## PRODUCT TERMINATION NOTIFICATION

PCN tracking number: PTNOBU-20150302-01

Photocoupler series for 4 Pin SMD type terminate the TA / TB packing option.

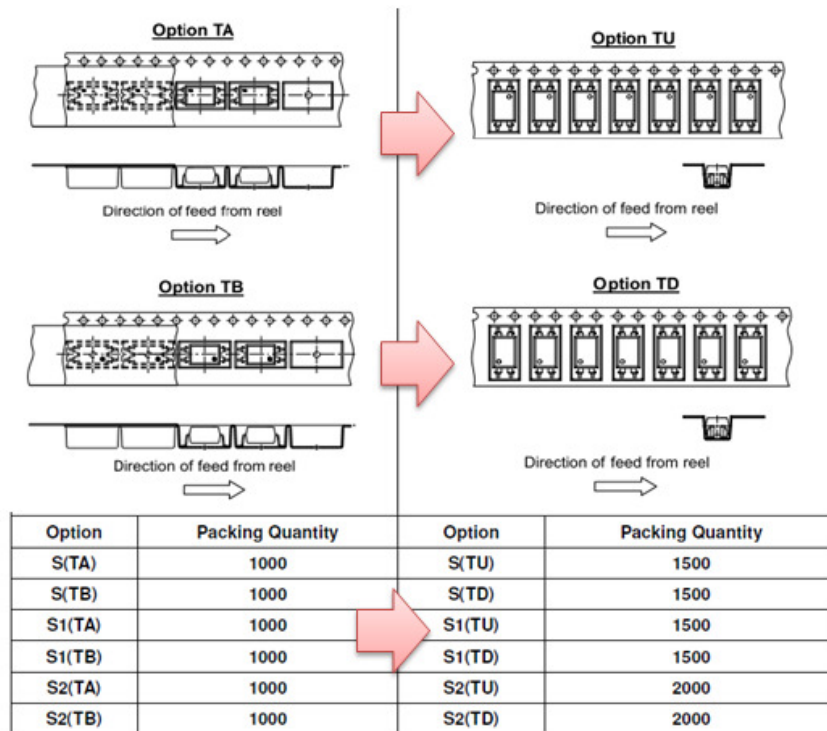
1. In order to improve customer production efficiency, Photocoupler series for 4Pin SMD type comprehensive change to TU / TD packing option, and cancel TA / TB Packing option.

The number of component contained in each reel will increase.

TA/TB轉換為TU/TD後，每捲依腳型不同可提升500到1000Pcs的包裝數量，一個大箱可容納更多材料，減少搬運次數，客戶打件時換料次數也能縮短。

Increase quantity for each reel and box . Reduce handling times and refueling time.

Option	Packing Quantity	Option	Packing Quantity
...S(TA)	1000	...S(TU)	1500
...S(TB)	1000	...S(TD)	1500
...S1(TA)	1000	...S1(TU)	1500
...S1(TB)	1000	...S1(TD)	1500
...S2(TA)	1000	...S2(TU)	2000
...S2(TB)	1000	...S2(TD)	2000
